Hg Delivery System Nozzle Discussion

Van Graves

25 Oct 2005

MERIT Mtg at MIT Oct 17-19

Conceptual Configurations

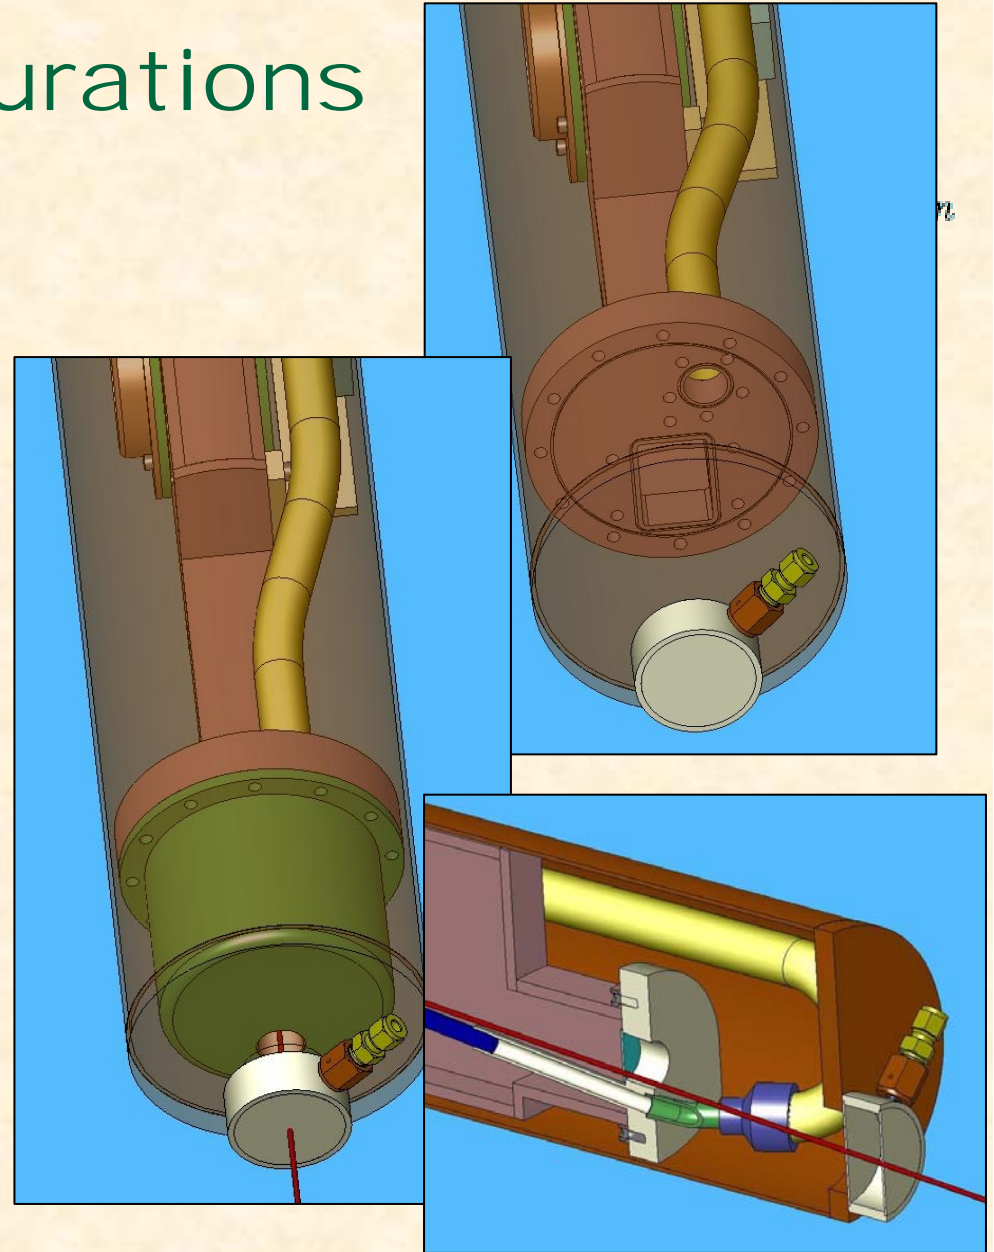
- Attaching plenum from up-beam end requires smaller diameter plenum
- Rigid supply tubing must bend towards center to accommodate flange bolt circle
- Non-plenum tubing requires Hg flow to bend away from center (adds 4 bends before 180-deg turn)

Removable Plenum Concept

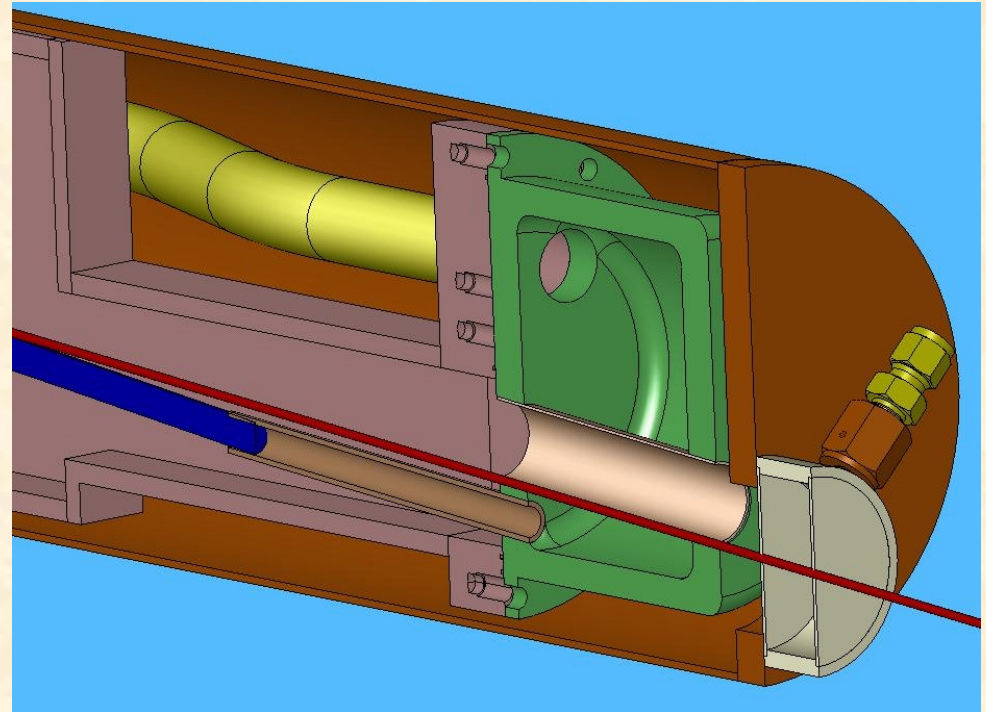
- Adding exterior bolts reduces plenum ID
- Beam tube positioning will be problem
- Plenum wall thicknesses may not be representative

Secondary Flange

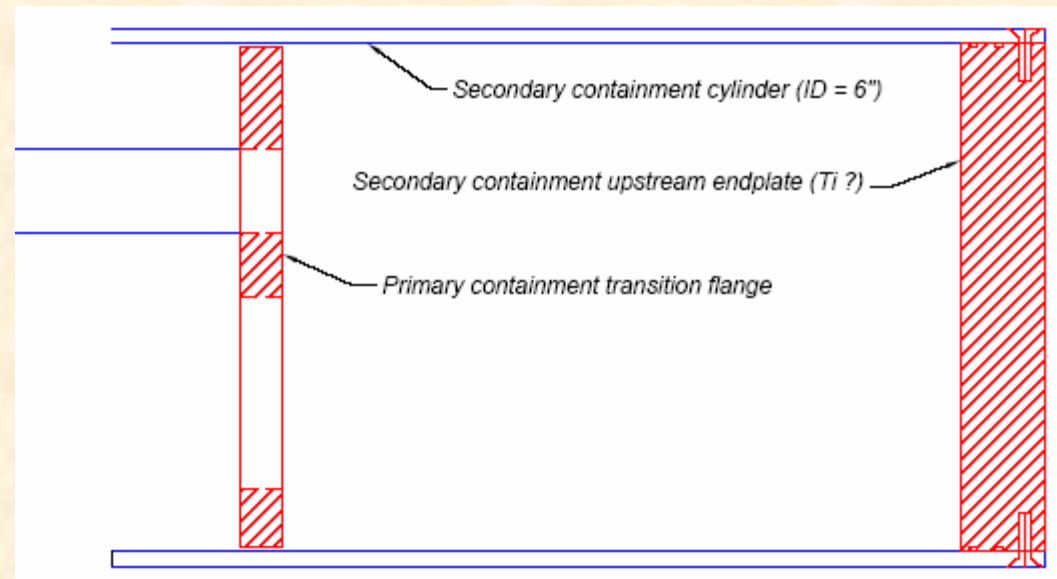
- Radial screws provide most clearance for removal of nozzle
- Secondary sleeve not thick enough for flat-head screws
 - Adding thickness reduces clearance for removing nozzle
- Requires fairly precise sleeve/flange fabrication to achieve proper sealing
